3GPP TSG-RAN Meeting #16 Marco Island, FL, U.S.A., 4 – 7, June, 2002

RP-020306

Title: Agreed CRs (R99 and Rel-4/Rel-5 Category A) to TS 25.201

Figure 2 - FDD layer 1 functions relationships by specification

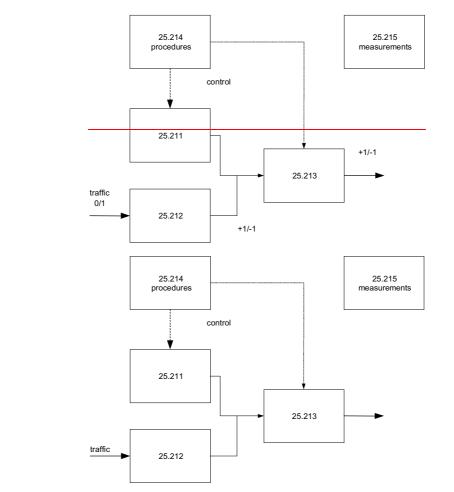
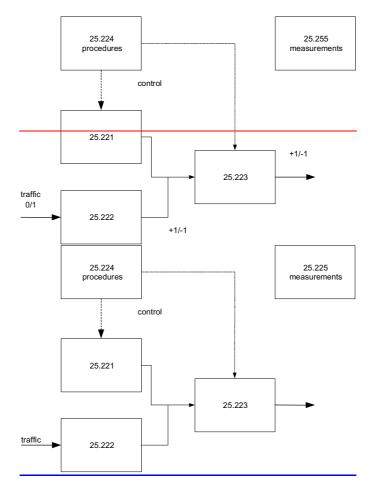
CR-Fc	orm-v5				
	CHANGE REQUEST					
z	25.201 CR 015 z rev - z Current version: 3.3.0 z					
For <u>HELP</u> on u	sing this form, see bottom of this page or look at the pop-up text over the z symbols	3.				
Proposed change	Proposed change affects: z (U)SIM ME/UE X Radio Access Network X Core Network					
Title: z	Downlink bit mapping					
Source: z	TSG RAN WG1					
Work item code: \mathbf{z}	TEI Date: z 2002-04-05					
Category: z	FRelease: zR99Use one of the following categories:Use one of the following releasesF (correction)2(GSM Phase 2)A (corresponds to a correction in an earlier release)R96(Release 1996)B (addition of feature),R97(Release 1997)C (functional modification of feature)R98(Release 1998)D (editorial modification)R99(Release 1999)Detailed explanations of the above categories canREL-4(Release 4)be found in 3GPP TR 21.900.REL-5(Release 5)	:				
Reason for change	The current description of value formats for the interfaces between the differe RAN1 specifications does not consider all types of signals. In principle, the display of value formats is not essential to be presented in those figures, and thus removed to avoid confusions. The number of the TDD measurement specification is incorrect.

Summary of chang	e: z The display of value formats on the interfaces between RAN1 specifications is removed. Correction of the number of the TDD measurement specification.	S				
Consequences if not approved:	Z Misleading information regarding value formats on the interfaces between RA specifications. Incorrect TDD measurement specification number.	N1				
Clauses affected:	z 4.2.6					
Other specs affected:	 z 4.2.6 z Other core specifications z Test specifications O&M Specifications 					
Other comments:	z Isolated impact analysis: The implementation of this CR does not have any impact on existing UE or UTRAN implementations.

Figure 2 - FDD layer 1 functions relationships by specification

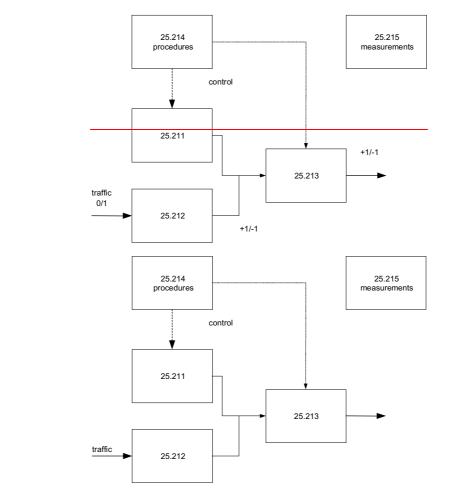
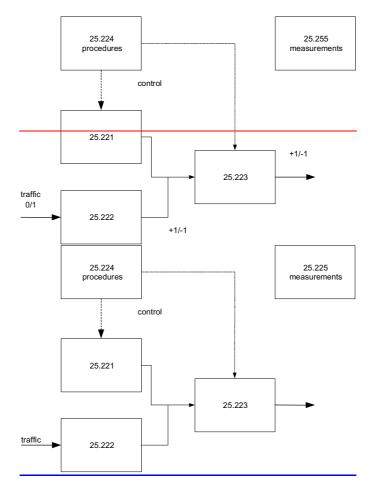
CR-Form-v5				
CHANGE REQUEST					
z	25.201 CR 016 z rev - z Current version: 4.2.0 z				
For <mark>HELP</mark> on u	ising this form, see bottom of this page or look at the pop-up text over the z symbols.				
Proposed change affects: z (U)SIM ME/UE X Radio Access Network X Core Network					
Title: z	Downlink bit mapping				
Source: z	TSG RAN WG1				
Work item code: z	TEI Date: z 2002-04-05				
Category: z	Use one of the following categories:Use one of the following releases:F (correction)2A (corresponds to a correction in an earlier release)R96B (addition of feature),R97C (functional modification of feature)R98D (editorial modification)R99D tetailed explanations of the above categories canREL-4be found in 3GPP TR 21.900.REL-5				
Reason for change	2 The current description of value formats for the interfaces between the different RAN1 specifications does not consider all types of signals. In principle, the display of value formats is not essential to be presented in those figures, and is thus removed to avoid confusions. The number of the TDD measurement specification is incorrect.

Summary of chang	<i>ge:</i> z The display of value formats on the interfaces between RAN1 specifications is removed. Correction of the number of the TDD measurement specification.				
Consequences if not approved:	z Misleading information regarding value formats on the interfaces between RAN1 specifications. Incorrect TDD measurement specification number.				
Clauses affected:	z 4.2.6				
Other specs affected:	z Other core specifications z Test specifications Z O&M Specifications Z				
Other comments:	z Isolated impact analysis: The implementation of this CR does not have any impact on existing UE or UTRAN implementations.

Figure 2 - FDD layer 1 functions relationships by specification

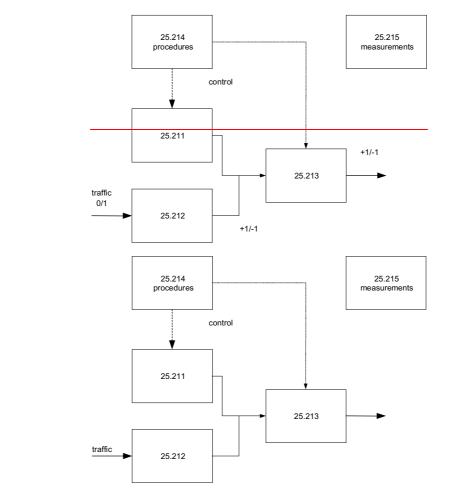
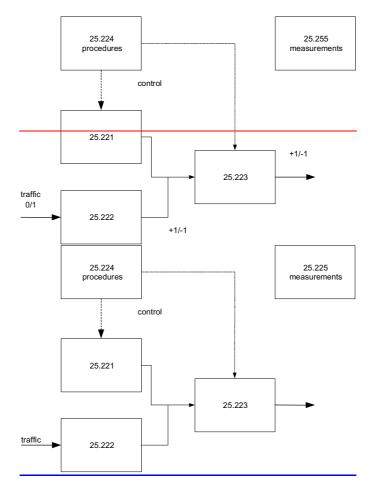
CR-Form-v					
	CHANGE REQUEST					
Z	25.201 CR 017 z rev - z Current version: 5.0.0 z					
For <mark>HELP</mark> on u	ising this form, see bottom of this page or look at the pop-up text over the z symbols.					
Proposed change	Proposed change affects: z (U)SIM ME/UE X Radio Access Network X Core Network					
Title: z	Downlink bit mapping					
Source: z	TSG RAN WG1					
Work item code: \mathbf{z}	TEI Date: z 2002-04-05					
Category: z	ARelease: zREL-5Use one of the following categories:Use one of the following releases:F (correction)2A (corresponds to a correction in an earlier release)R96B (addition of feature),R97C (functional modification of feature)R98D (editorial modification)R99D (editorial modification)R99D tetailed explanations of the above categories canREL-4be found in 3GPP TR 21.900.REL-5					
Reason for change	e: z The current description of value formats for the interfaces between the different RAN1 specifications does not consider all types of signals. In principle, the display of value formats is not essential to be presented in those figures, and is thus removed to avoid confusions. The number of the TDD measurement specification is incorrect.

Summary of chang	ge: z The display of value formats on the interfaces between RAN1 specifications is removed. Correction of the number of the TDD measurement specification.					
Consequences if not approved:	z Misleading information regarding value formats on the interfaces between RAN1 specifications. Incorrect TDD measurement specification number.					
Clauses affected:	z 4.2.6					
Other specs affected:	z Other core specifications z Test specifications O&M Specifications					
Other comments:	z Isolated impact analysis: The implementation of this CR does not have any impact on existing UE or UTRAN implementations.
